RECEIPT DATE: 10-25-22 **ONSITE SEWAGE DISPOSAL SYSTEM** P 5721609

APPROVAL DATE: 12/21/22 **PERMIT: TANK REPLACEMENT** A _____

PROPERTY ADDRESS: 14700 Carriage Mill Road

SEPTIC SYSTEM
14700 CARRIAGE MILL ROAD
LOT 1 PHASE 1 CARRIAGE MILL FARMS
TAX MAP No. 8 GRID No. 16 PARCEL No. 158
4TH ELECTION DISTRICT HOWARD COUNTY, MARYLAND
SCALE 1"=30' DATE: DECEMBER 6, 2022

SEPTIC PROFILE
SCALE: 1"=30'

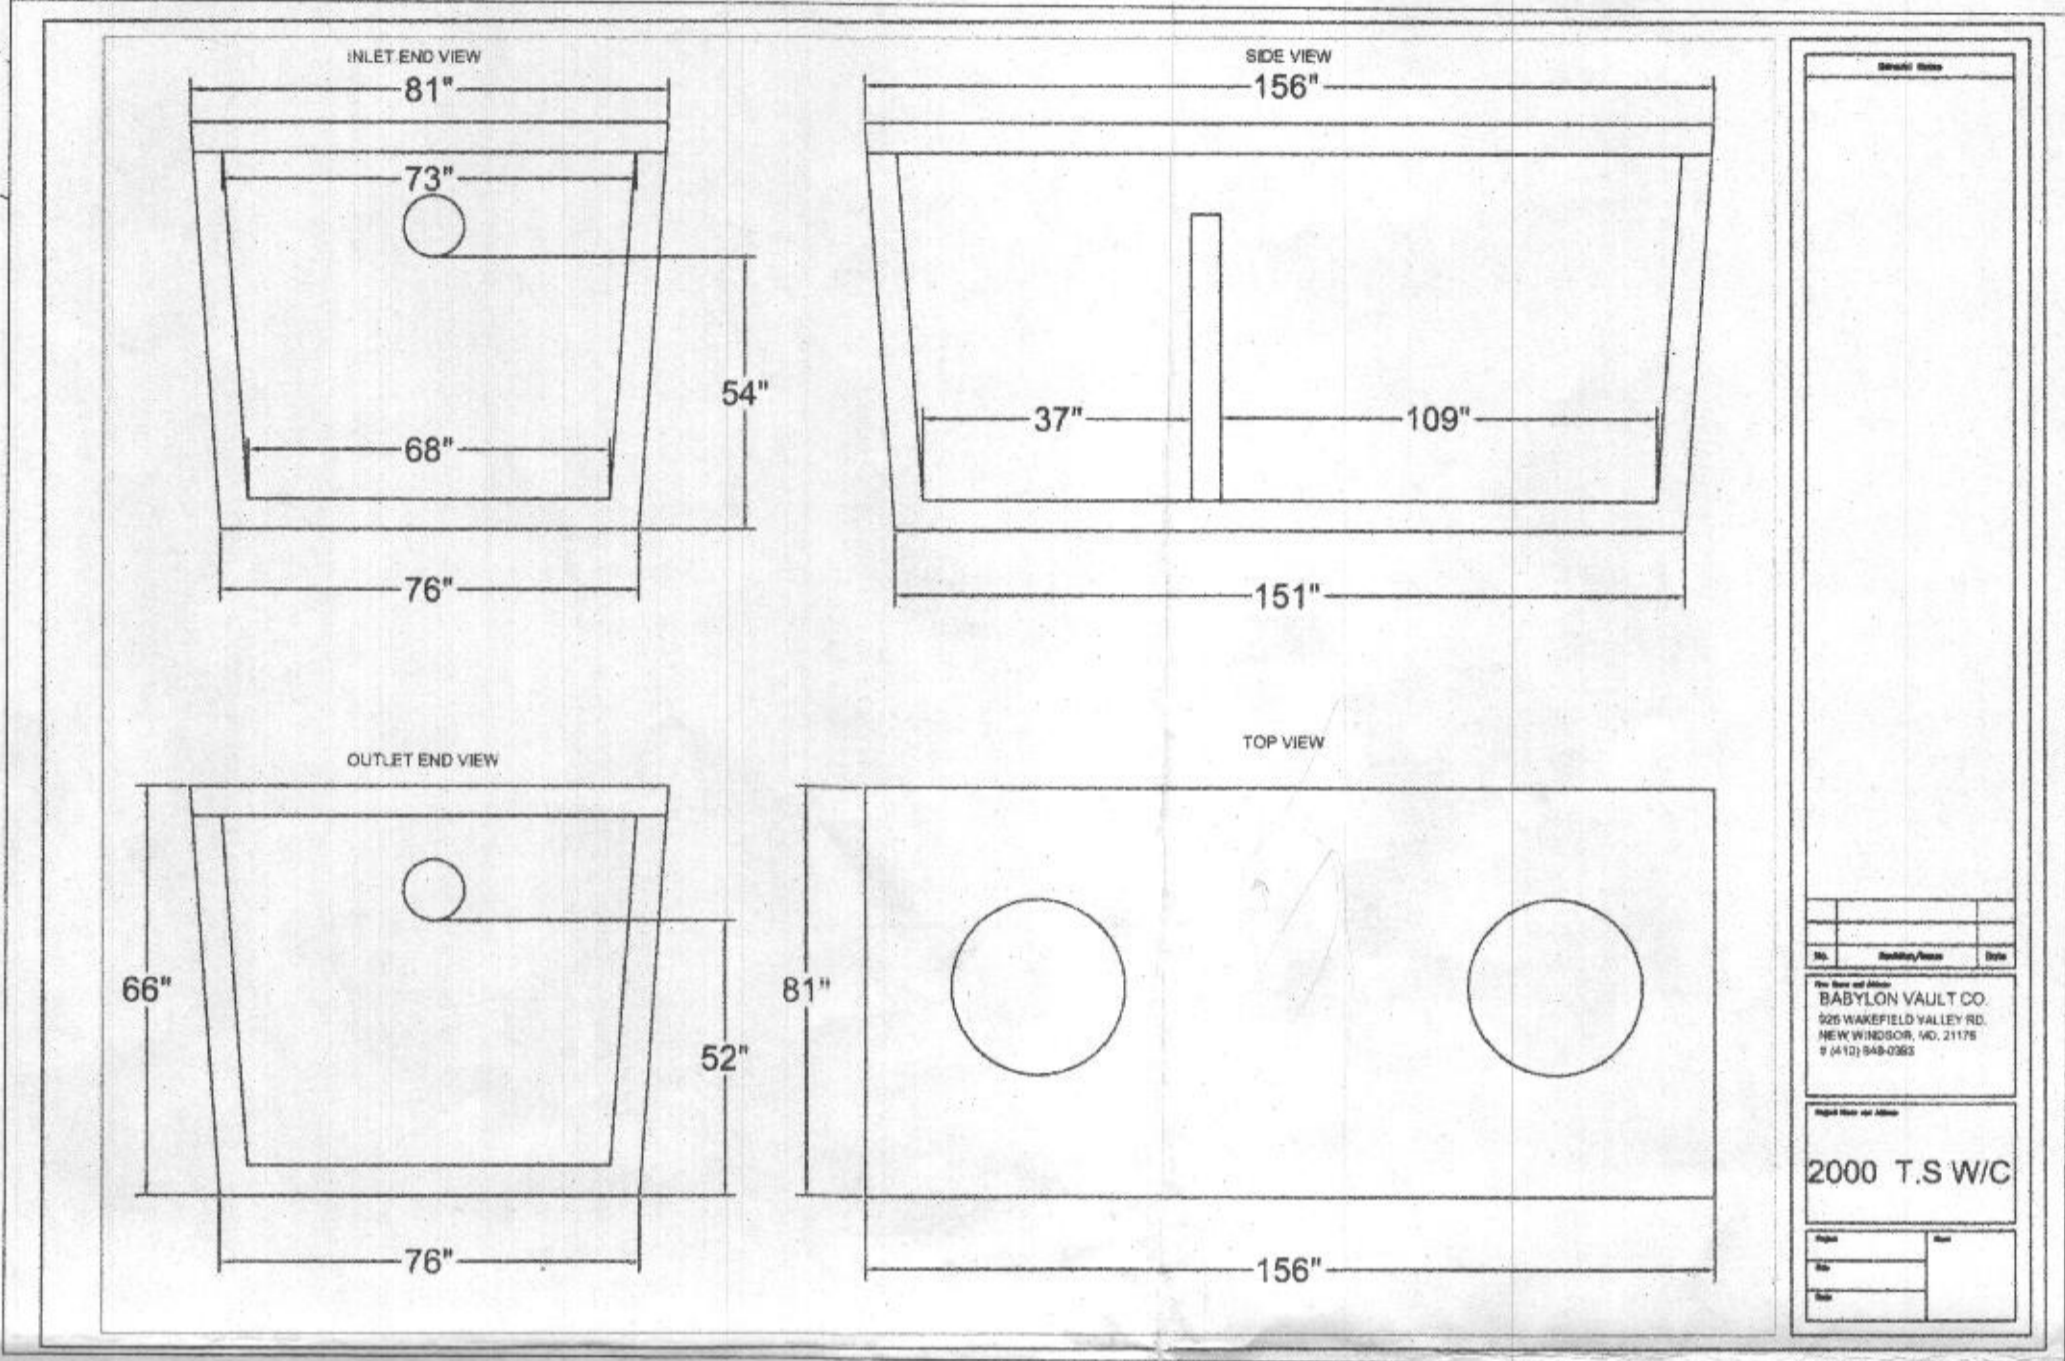
On the revised OSDS Plan, I'm getting a 7% fall from the cleanout to the tank.

1. How was the invert elevation out of the house determined?
2. Add scale (1:30) to plan.
3. The length of the SHC in the septic profile (scale 1:50) doesn't match the length shown on the layout which appears to be 1:30 scale.
4. The pipe in the trench detail exceeds max depth of 4 feet.
5. Note #5 needs to be changed because the existing trenches won't need upgrading.
